## **Addendum #02 for RFB #911800-02**

Project Name: IVH-Mechanical & Electrical Distribution System Replacement

Addendum #2:

Iowa Veterans Home  
Power Plant Upgrades – DAS #9118.00  
Addendum #2

1 ENLARGED LOWER LEVEL MECHANICAL PLAN - SOUTH  
SCALE: 1/4" = 1'-0"

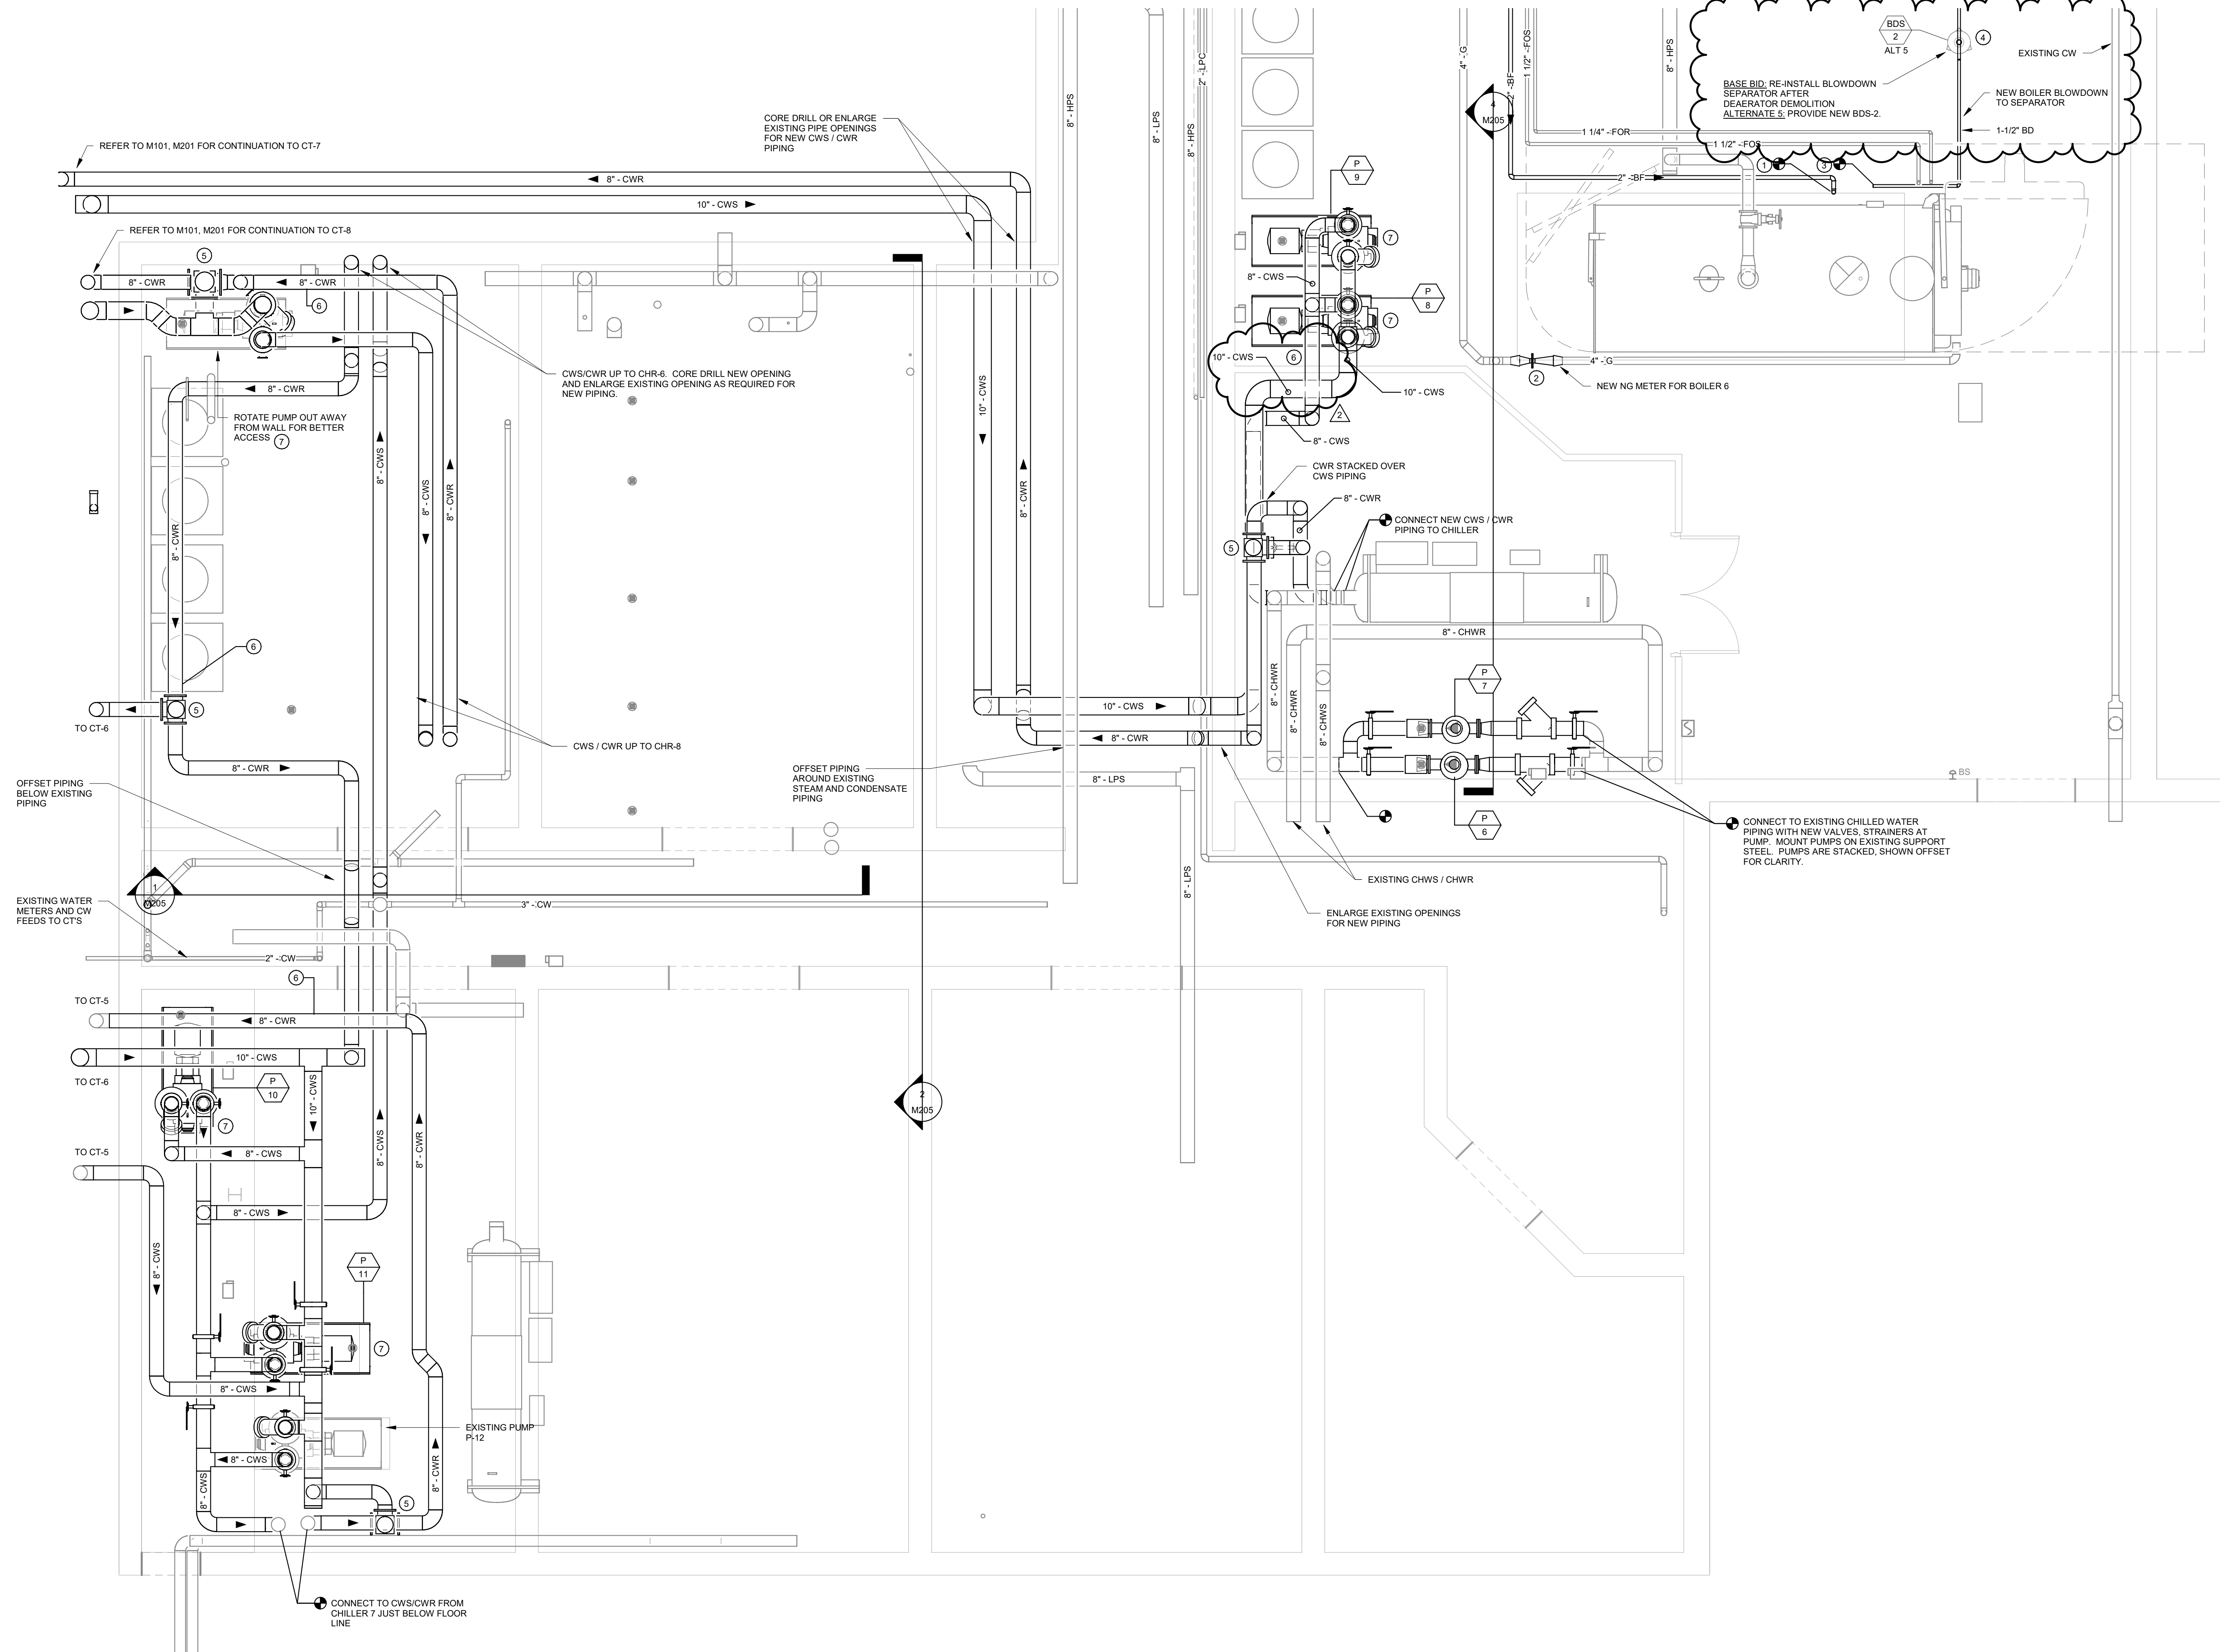
- d. **ADD** Keynote 5 at north side stair of Boiler 5.
- 5. Drawing M201 Enlarged Mechanical Plans
  - a. **REVISE** Keynote 6: Provide new connection from cooling tower chemical treatment system into condenser water piping with one PVC pipe manifold and shut-off valve for treatment, and one inch pipe and shut-off valve for connection to blowdown valve.

- b. **ADD** Keynote 6 at 10" CWS near pump P-8.
  - c. **CLARIFY** that PVC piping in mechanical room where pumps P-10 and P-11 are replaced shall be all new with all new valves, except valves at pump P-12 to remain.

- d. **CLARIFY** that all new base mounted and inline chilled and condenser water pumps shall have new shall have flexible pump connector, shut-off valve and strainer on suction inlet, and flexible pump connector, check valve and shut-off valve with memory stop on discharge outlet with new pressure gauge and tapings.

- e. **ADD** to Keynote 4: Provide new blowdown separator BDS-2 as part of Add Alternate 5.
  - f. **REVISE** notes at blowdown separator to: Base Bid: Re-install salvaged blowdown separator after deaerator demolition. Alternate 5: Demolish blowdown separator and install new BDS-2.

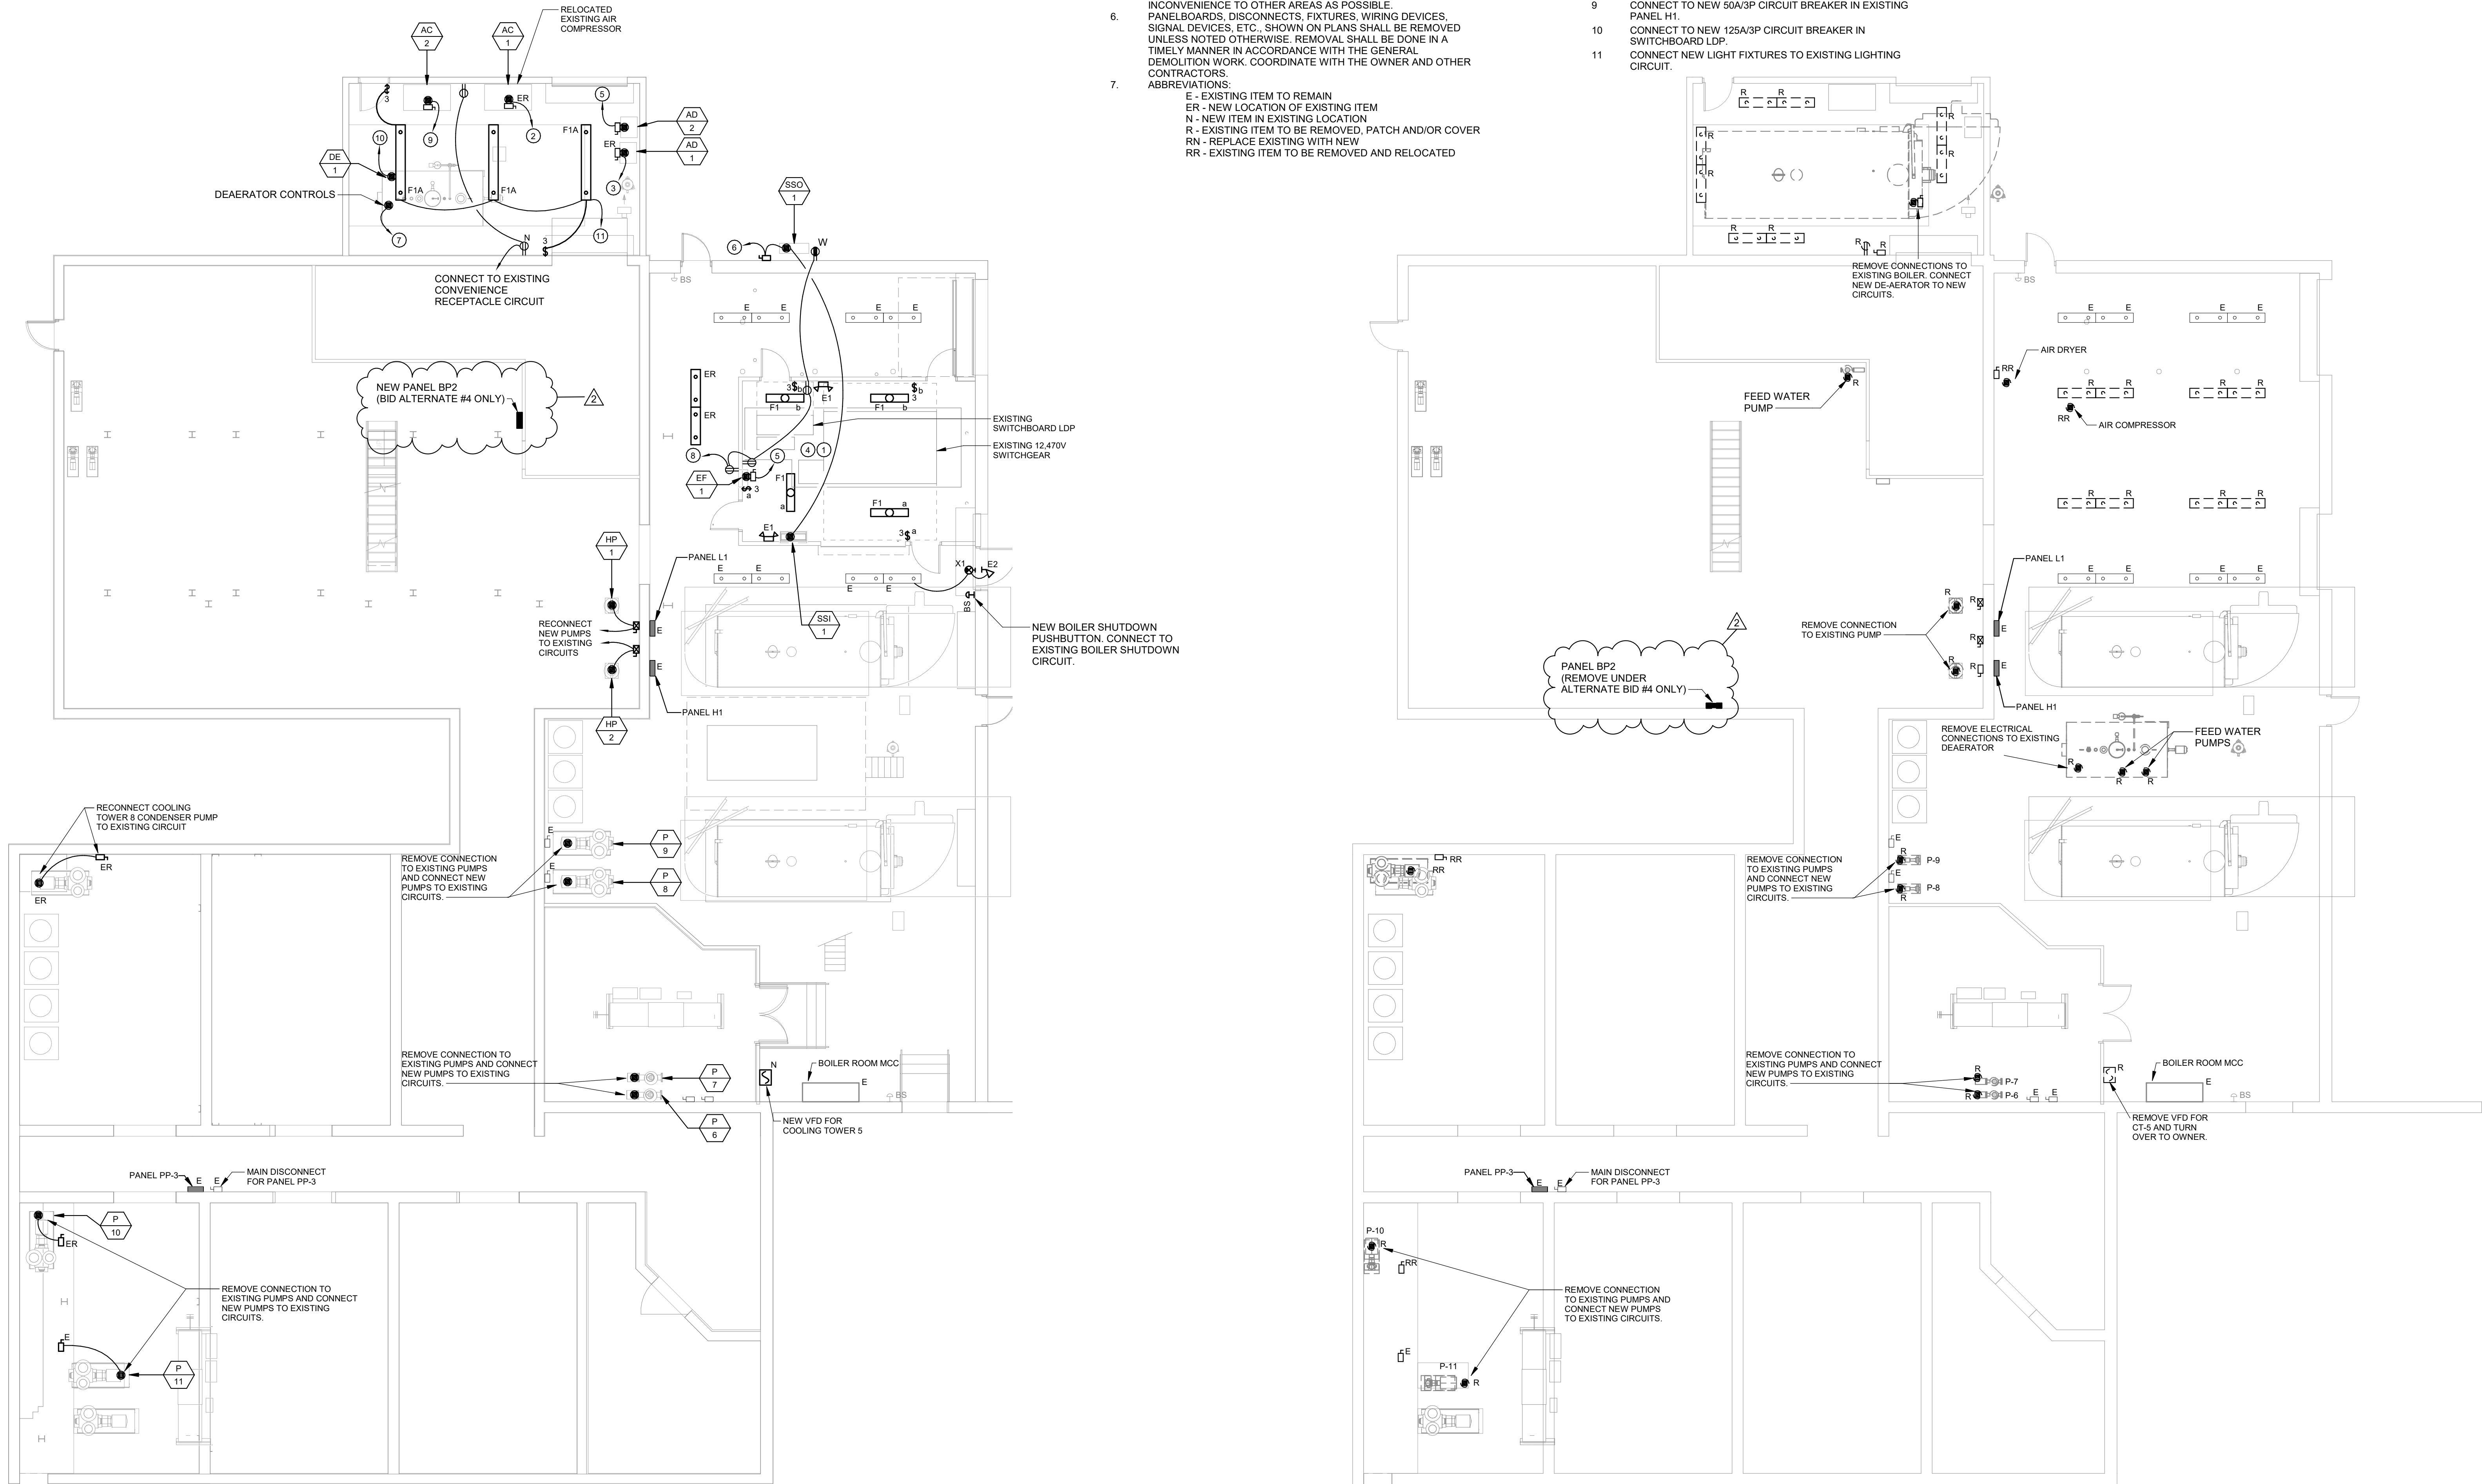
- Boiler #4: Is the blowdown separator saved to be reinstalled? It is shown on prints. Some prints as still in use.
  - Blowdown separator shown as demolished MD 100, not reused.

- i. 100A/3P breaker in Panel H1
    - ii. 20A/1P breaker in Panel L1
- 3. Drawing MD100 Power Plant Lower Level Demolition Plan
  - a. **REVISE** notes at existing blowdown separator for Boiler 5 & 6 to: Base Bid: Demolish piping from blowdown separator, including boiler drain and blowdown, vent, drain and CW. Salvage blowdown separator for re-installation in same location. Alternate 5: Demolish all piping associated with Base Bid, demolish blowdown separator as well.

- b. **CLARIFY** that existing PVC condenser water piping in area where P-10 and P-11 are demolished is to be demolished as well, except valves at P-12 to remain.
